# **CONSTRUCTION SUMMARY**

**Kingsmen (Thames) Inc. / Havelock Corners (Kingsmen)**

Lot/Unit: 2 Phase/Building: 4A Model/Floor Plan: Spencer (4204) Elev A 4 Bed - 4+1 Bath

# **GROUND FLOOR EL. A**

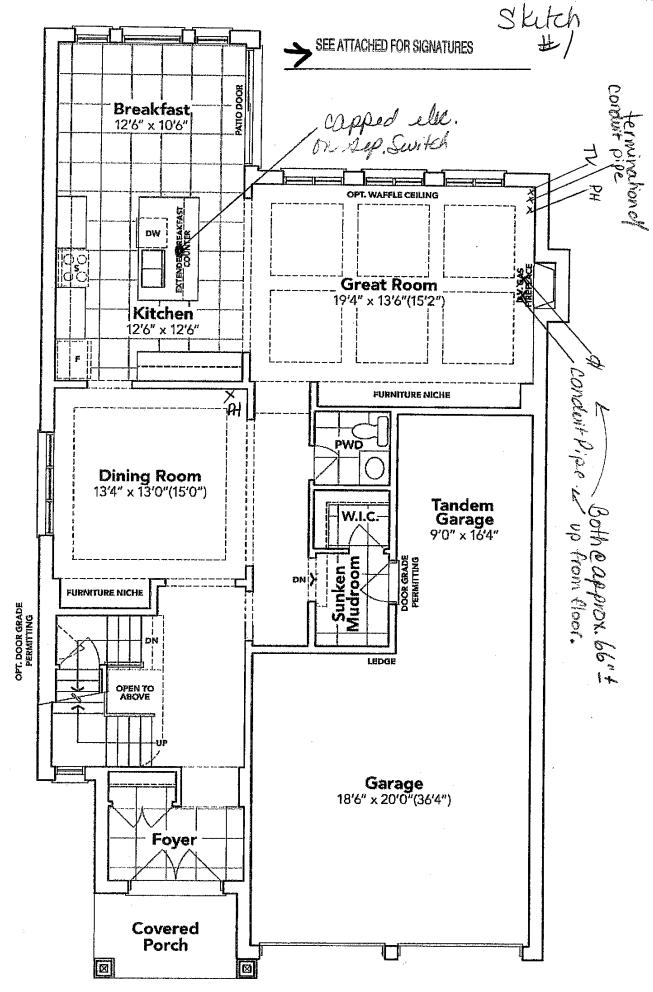
1 - To supply & install the standard T.V. rough in in the great room and master bedroom see	
sketch # 1 & # 2	
Note:	
1 - To supply & install the standard Phone rough in in the great room, dining room and upper hallwaysee sketch # 1 & # 2	
Note:	
<b>1 -</b> To SUPPLY AND INSTALL AN ADDITIONAL BASIC RECEPTACLE (NOT DEDICATED) at approx. 66 " + - up from the floor next to the upgraded conduit pipe	
Note: centered to the F/P mantle see sketch # 1	
1 - To SUPPLY AND INSTALL CONDUIT FOR TV OVER THE FIREPLACE at approx. 66 " + - up from the floor and – TERMINATED IN SAME ROOM next to + - the standard T.V. rough in the great room see sketch # 2	
Note:	
1 - To SUPPLY AND INSTALL EXTRA CEILING BOX ROUGH IN CAPPED (DOES NOT INCLUDE SWITCH) over the breakfast bar in the kitchen see sketch # 1	
Note: This capped ceiling elec. will be connected to a sep. switch, switch is sold sep.	
1 - To supply & install AN ADDITIONAL SINGLE POLE SWITCH connected to the upgraded ceiling capped elec. over the breakfast bar in the kitchen.

### SECOND FLOOR EL. A

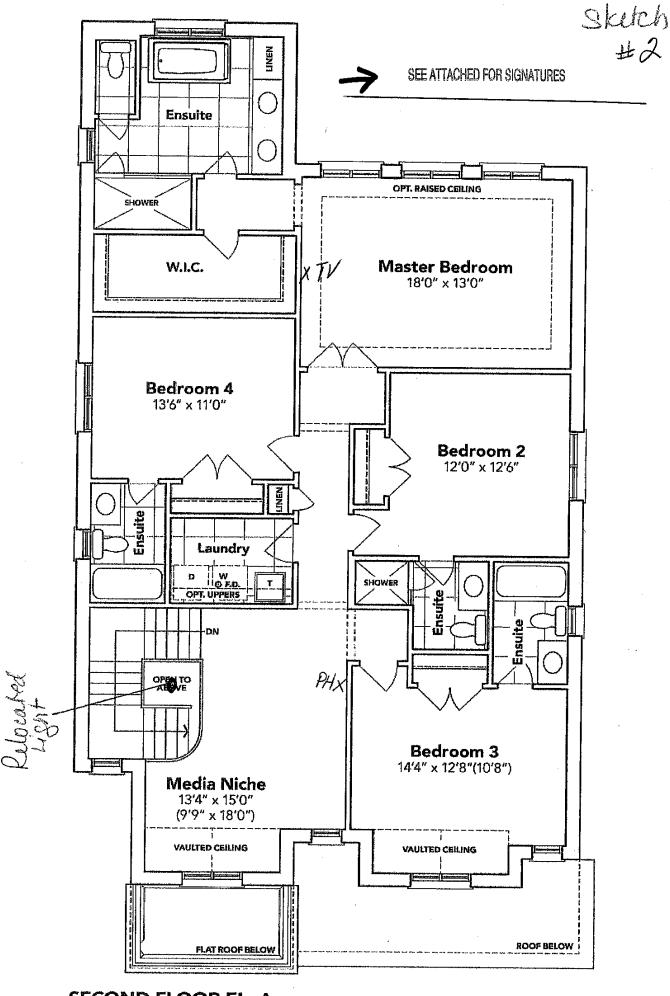
Note:	
1 - Relocate the standard ceiling light from the upper stair landing to the O.T.B. area on the second floor see sketch # 2	
Note:	
	1 - To supply & install the standard Phone rough in in the great room, dining room and upper hallwaysee sketch # 1 & # 2  Note:  1 - To SUPPLY AND INSTALL AN ADDITIONAL BASIC RECEPTACLE (NOT DEDICATED) at approx. 66 " + - up from the floor next to the upgraded conduit pipe Note: centered to the F/P mantle see sketch # 1  1 - To SUPPLY AND INSTALL CONDUIT FOR TV OVER THE FIREPLACE at approx. 66 " + - up from the floor and – TERMINATED IN SAME ROOM next to + - the standard T.V. rough in in the great room see sketch # 2  Note:  1 - To SUPPLY AND INSTALL EXTRA CEILING BOX ROUGH IN CAPPED (DOES NOT INCLUDE SWITCH) over the breakfast bar in the kitchen see sketch # 1  Note: This capped ceiling elec. will be connected to a sep. switch, switch is sold sep.  1 - To supply & install AN ADDITIONAL SINGLE POLE SWITCH connected to the upgraded ceiling capped elec. over the breakfast bar in the kitchen.  Note:  1 - Relocate the standard ceiling light from the upper stair landing to the O.T.B. area on the second floor see sketch # 2
